PLANNING REPORT

ID-3 – Amazon Cell Booster

26-060ARTW

Site Location Map

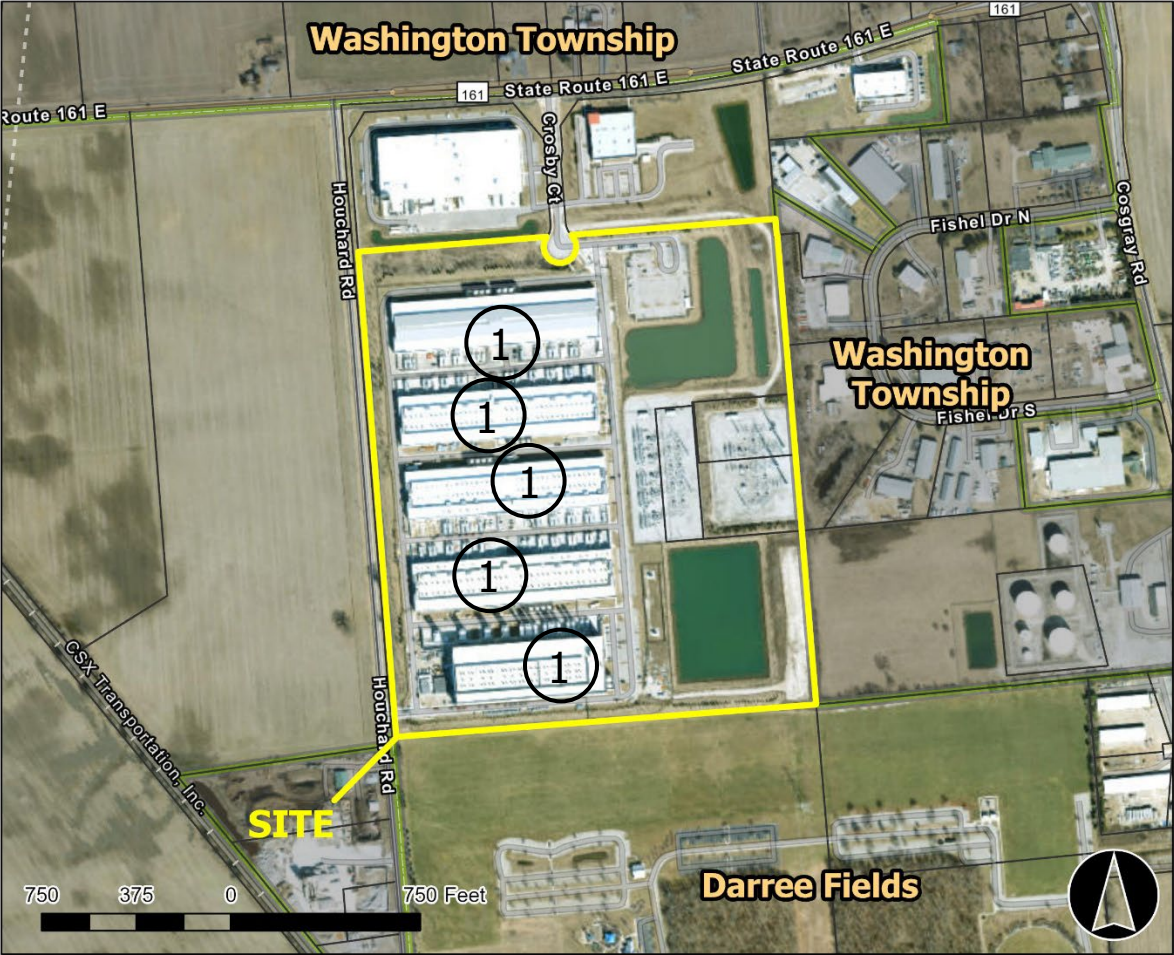
Wireless Communications Facilities Review Analysis	
Criteria	Review
1. The Antennas are designed to be as unobtrusive as possible, do not extend more than 20 feet above the highest point of the main roof deck or supporting structure, and complies with all applicable provisions.	Criterion Met W/ Conditions. The proposed antennas and equipment, together with all associated equipment, shall be screened fully within the existing screening walls, with no portion of the antennas or associated equipment exceeding the height of the screening walls. The antennas and associated equipment shall maintain a neutral color that is identical to, or closely compatible with, the color of the existing structure. Any associated cables shall be trimmed and secured to fit closely against the structure.

- 1) The antennas and associated equipment will be completely screened within the existing screening walls, with the height of the antennas not exceeding the height of the screening walls;
- 2) The antennas and associated equipment shall maintain a neutral color that is identical to, or closely compatible with, the color of the existing structure; and
- 3) Any associated cables should be trimmed to fit closely to the structure.
